CITY OF MIAMI

ADDENDUM NO. 5

INVITATION TO BID NO. 08-09-021

ATHALIE RANGE PARK FIELD IMPROVEMENTS B-39507

**STANDARD STORM DRAINAGE DETAIL
EXFILTRATION TRENCH**

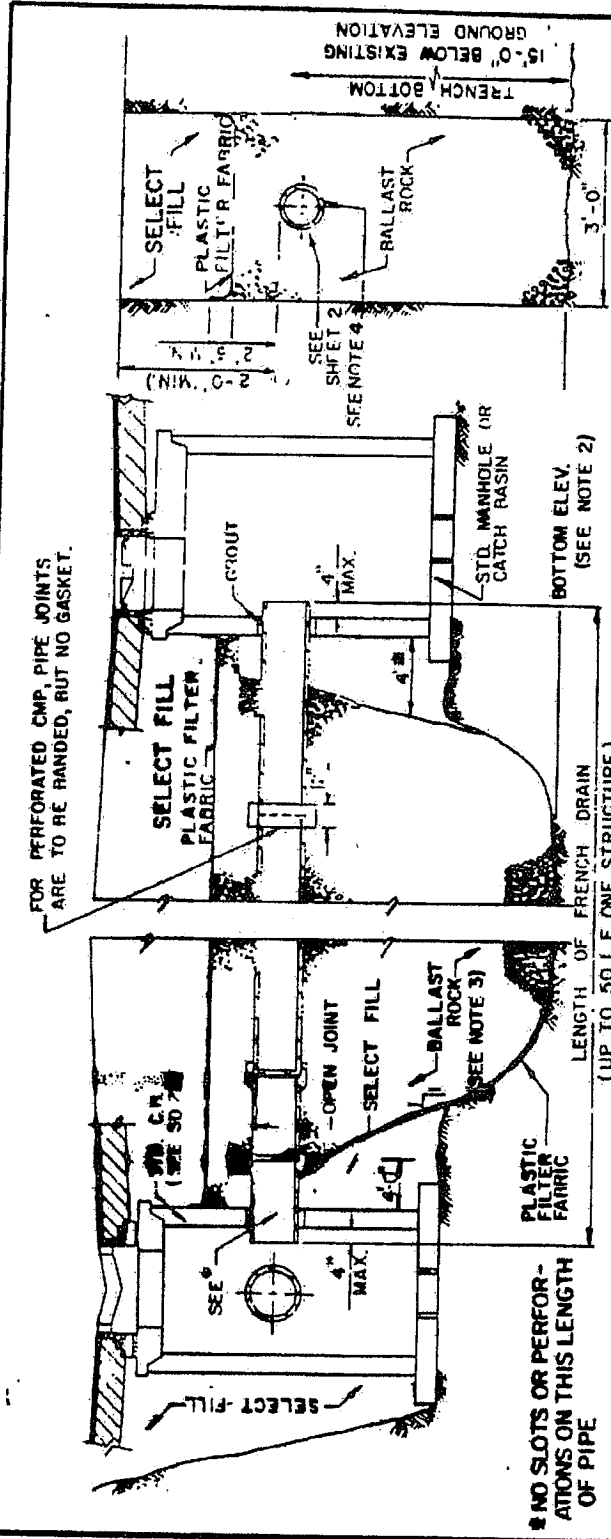
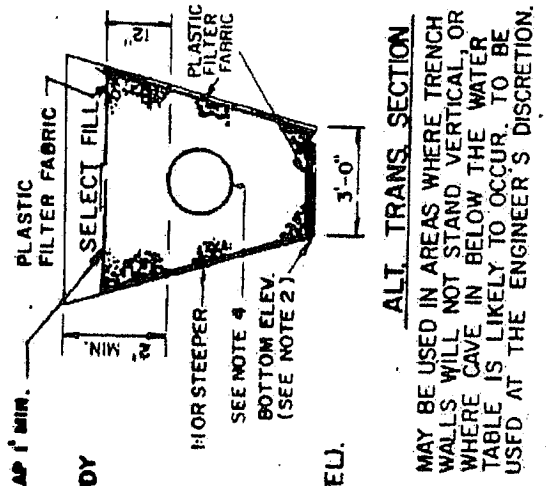
- Q1. The drawings and Addendum 3 refer to, but do not include, Miami Dade Standard detail SD 1.1 as controlling the aggregate depth of the French drain. We are unable to locate this detail on the Miami Dade website of design and construction standards and details. Can you provide a copy of this important detail, or direct us to its location on the website?
- A1. The drawing is available on the CIP website a part of this Addendum.
